86 MW Altamont Wind Farms *Final Supplemental Environmental Impact Report* *2018 CUP Extension*

*Final Supplemental Environmental Impact Report
2018 CUP Extension*

*PREPARED FOR: COUNTY OF ALAMEDA COMMUNITY DEVELOPMENT AGENCY,
PLANNING DEPARTMENT*

APPENDIX A
COMMENT LETTERS
AND
RESPONSE TO COMMENTS

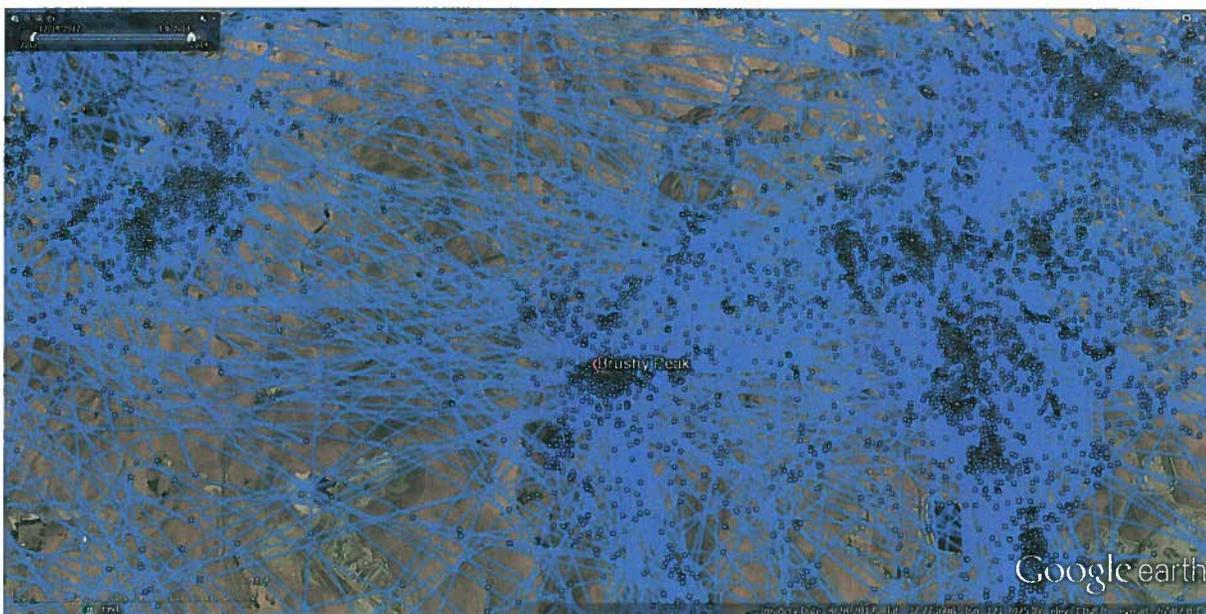
The District is also concerned about the uncertainty surrounding the location of the project outlined in the NOP. The proposed project would extend CUPs for 828 existing wind turbines distributed across approximately 14,000 acres of the 50,000 acre APWRA. According to the NOP, AWI is in discussions with other wind farm operators to exchange some of its wind turbines for an equal number of wind turbines on other parcels (i.e. asset exchange), which would result in AWI operating wind turbines on parcels of land other than where it currently operates (Figure 2 in the NOP). This is problematic because it is difficult to assess project footprint and impacts if the exact number, placement and configuration of the wind turbines to be covered by the CUP extensions are unknown. For example, avian use and fatalities in the APWRA are not evenly distributed (Smallwood et al. 2009b). In the case of golden eagles, there appear to be clusters of high use in the APWRA (see Figure 1, next page). If AWI's asset exchange results in AWI operating wind turbines for an additional 3 years in a high eagle use area that would otherwise be shut down by existing repowering agreements, then higher golden eagle take may result than was estimated by the existing 2013 EIR and consequently any proposed mitigation measures would be rendered inadequate.
